## Change in Zoning Pre-Application Staff Report

<b>Case No:</b>	17ZONE1000
<b>Project Name:</b>	Marilla Warehouse
<b>Location:</b>	4819 Poplar level road
<b>Owner(s):</b>	M&C Rentals
<b>Applicant:</b>	M&C Rentals
<b>Representative(s):</b>	Land Design & Development, Inc.
<b>Project Area/Size:</b>	1.4 acres
<b>Existing Zoning District:</b>	R-4
<b>Existing Form District:</b>	SMC, Suburban Marketplace Corridor
<b>Jurisdiction:</b>	Louisville Metro
<b>Council District:</b>	10 – Pat Mulvihill
<b>Case Manager:</b>	Joel P. Dock, Planner I

- **Change-in-Zoning** from R-4, Single-Family Residential to CM, Commercial-Manufacturing
- **Detailed District Development Plan**

*Potential Wetlands are hatched in Blue  
Hydric Soils are indicated with vertical, green line.  
Protected Waterway buffer heatched in blue.*

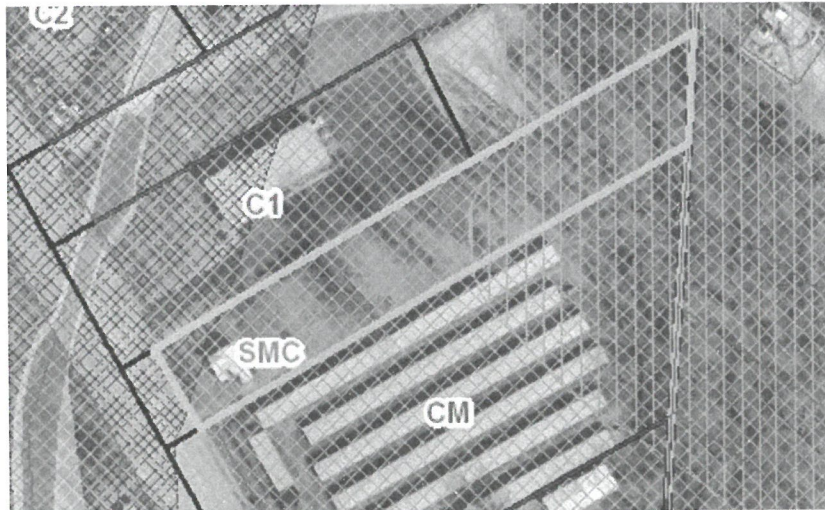
Environmental constraints may be present towards the rear of the property. LOJIC data reveals potential wetlands and hydric soils on the property, and the site-plan identifies “non-jurisdictional isolated wooded wetland.” A Protected Waterway buffer may be present at the front of the property as well. The applicant should work towards identifying these constraints and mitigating as appropriate or providing required buffers and preservation of these constraints.
